Addendum Number 1

Issued 4/26/2024

Franklin Active Adult Center (AAC)

160 E. Adams St.
Franklin, IN 46131

SITE PLAN

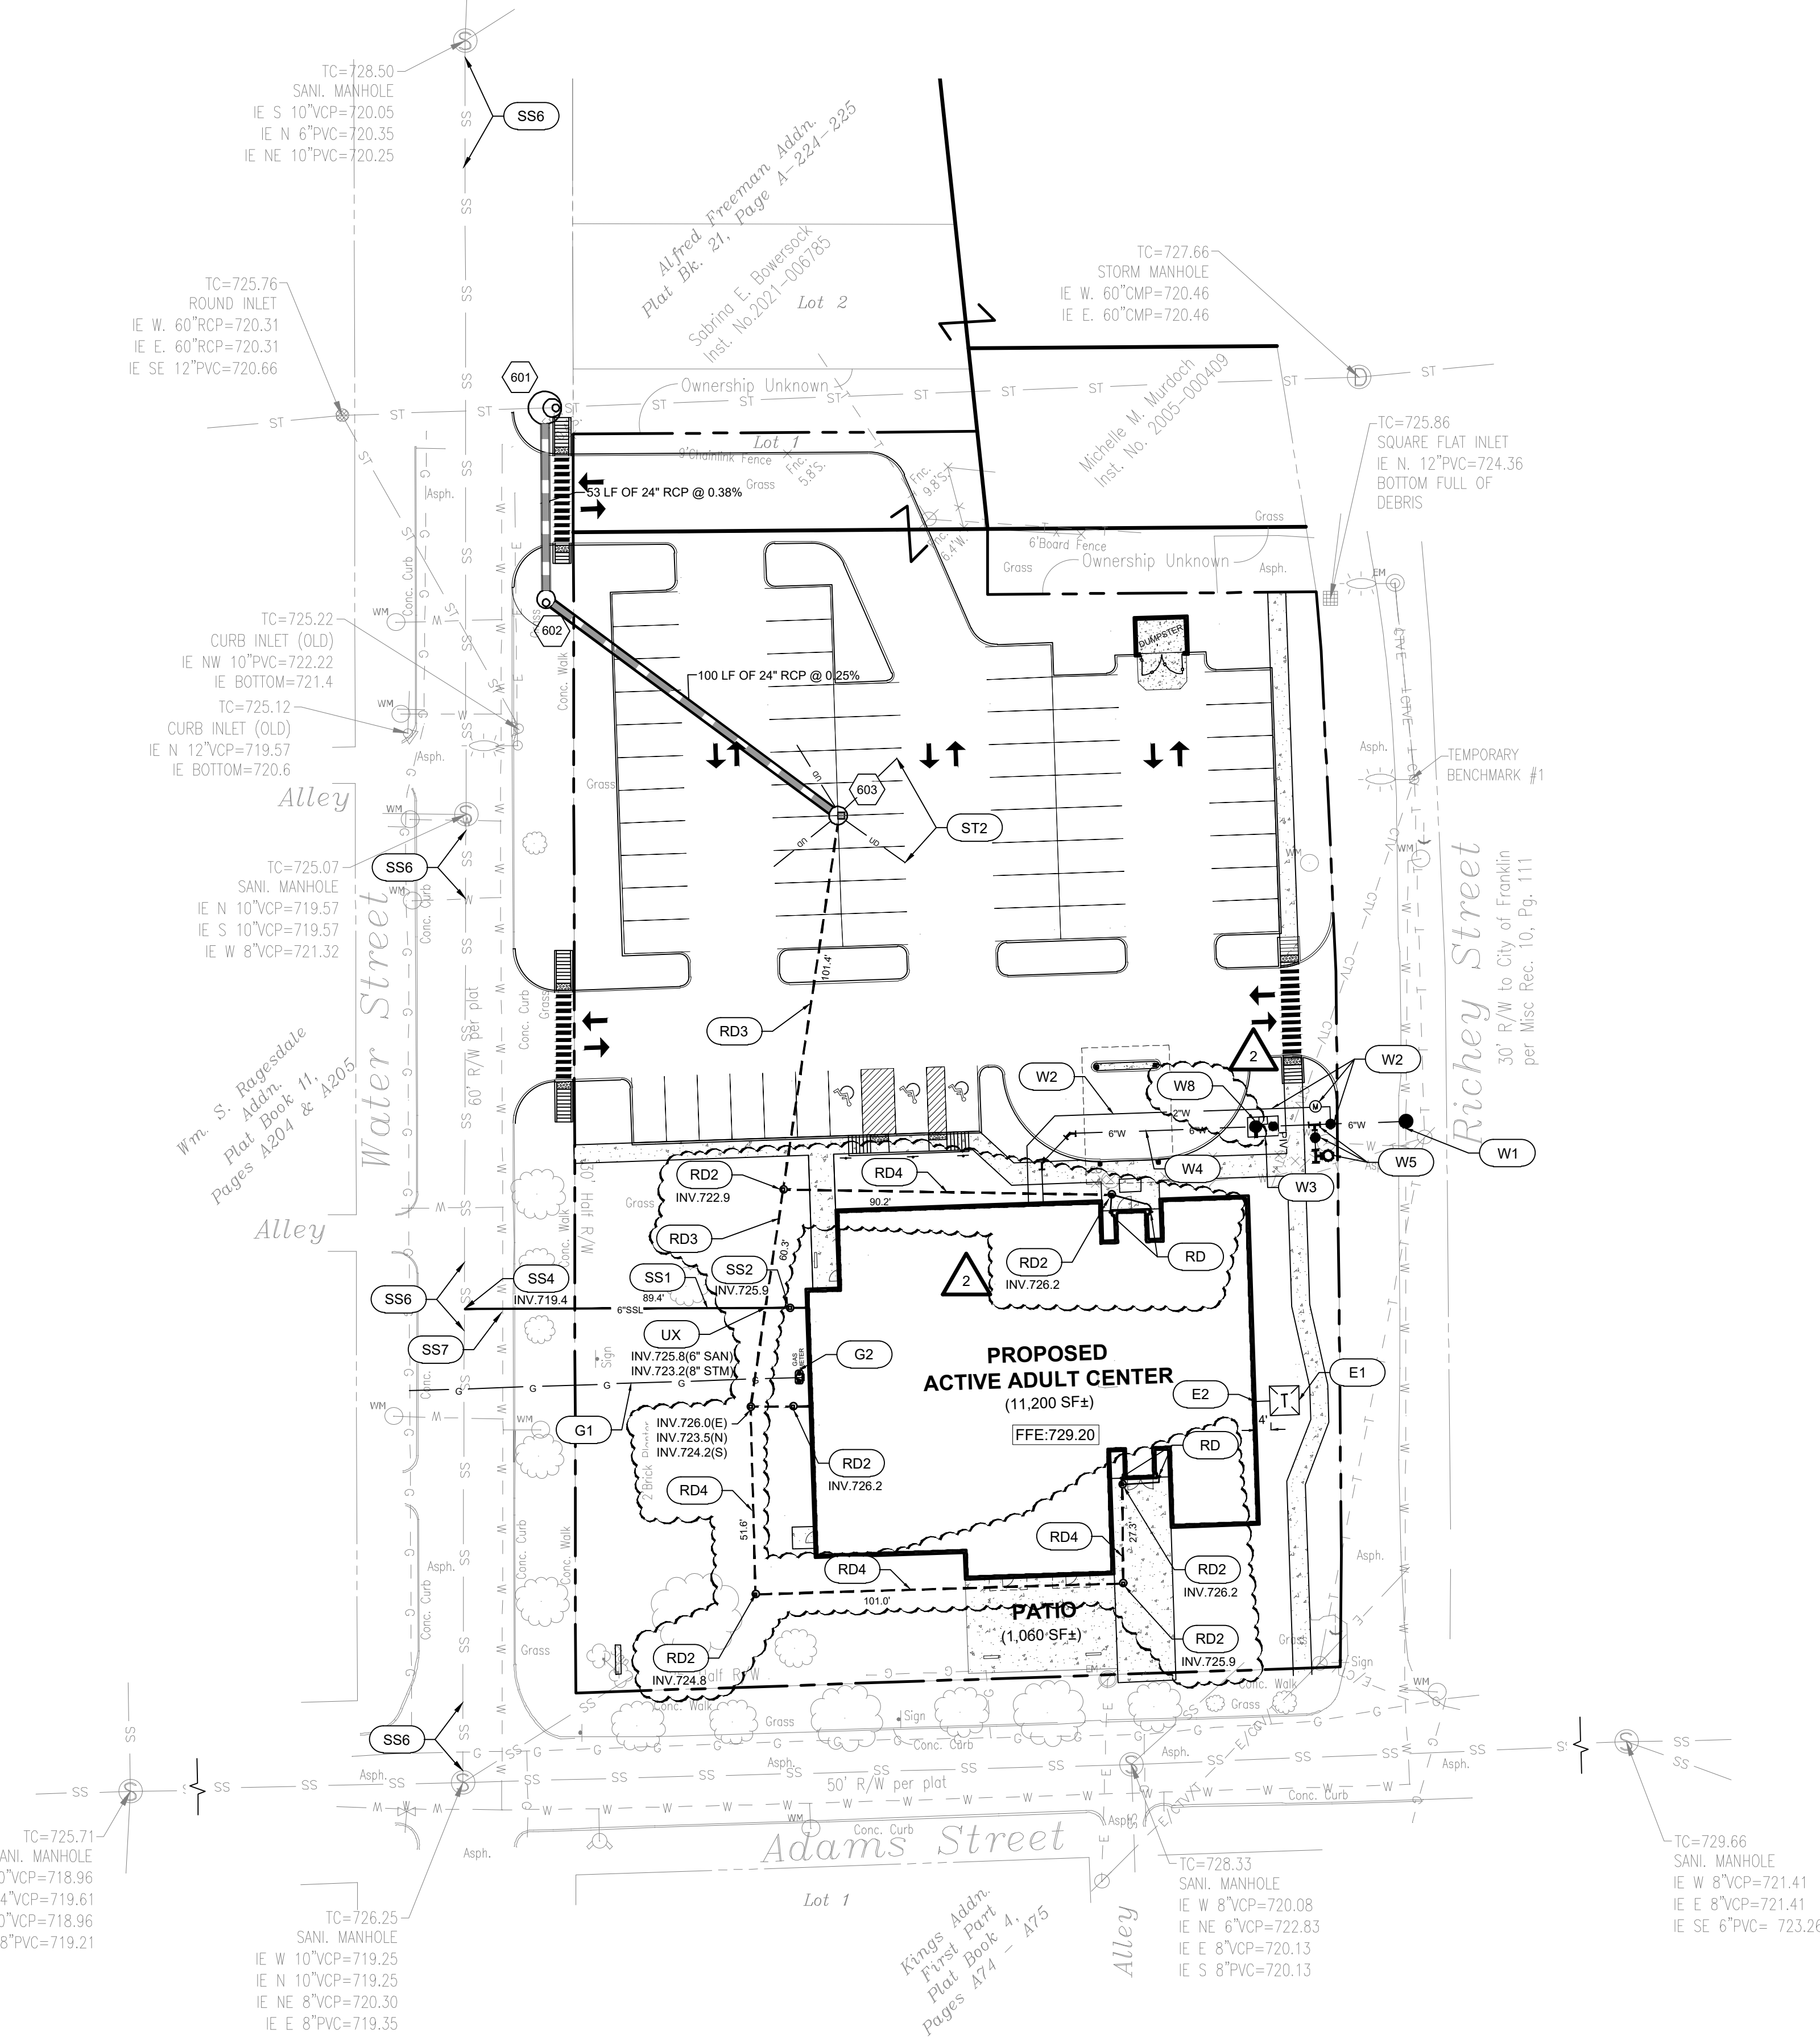
- Item No. 23** Site Civil C201: Add note for Plaza and Entry Walk joint patterns, plus drainage openings thru knee wall as shown. Attached.
- Item No. 24** Site Civil C401: Remove note ST3 (reference to detention system). Add note RD4. Add graphics for connecting vestibule roof drains to storm system. Add note W8 to plan indicating FDC location. Attached.
- Item No. 25** Landscape L101: Add note for knee wall openings and drainage in landscape bed as shown. Attached.

FIRST FLOOR DIMENSION PLAN

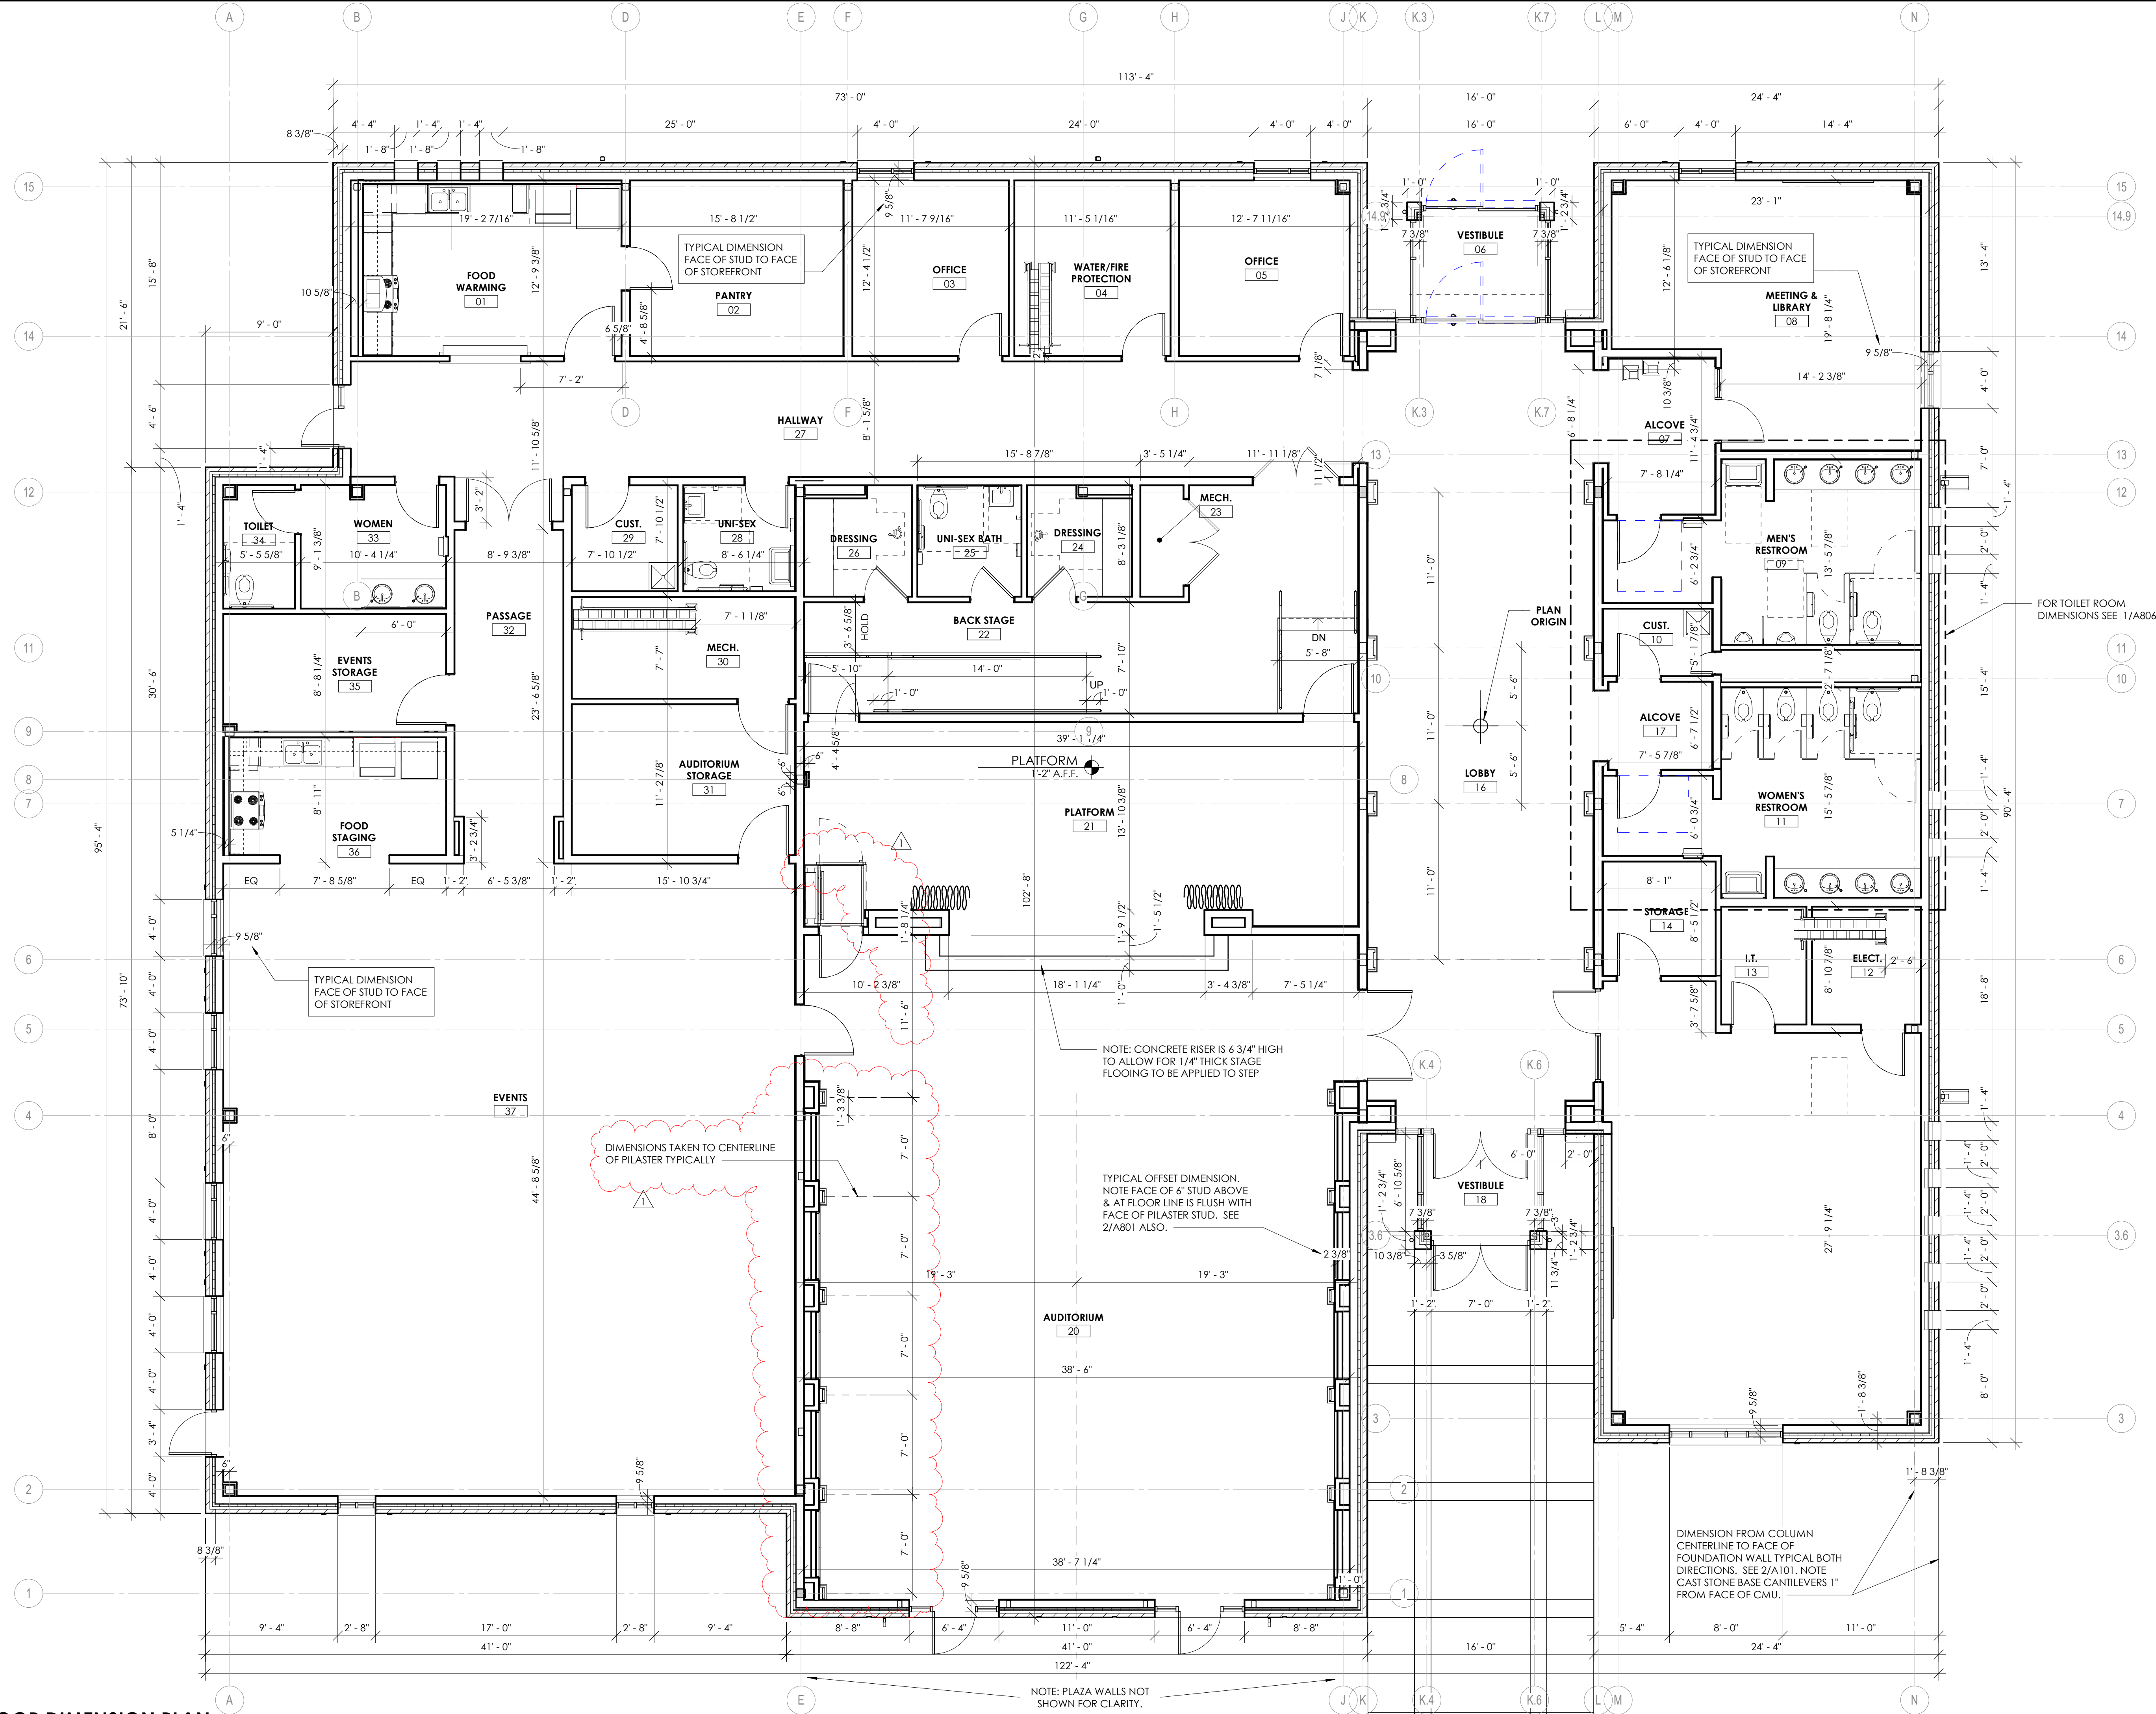
- Item No. 26** Sheet A101D & A101N: Add enlarged plan callout 4/A121 at Platform Lift on A101N. Remove walls on east and north at lift. Coordinate revised dimensions on A101D. Attached.
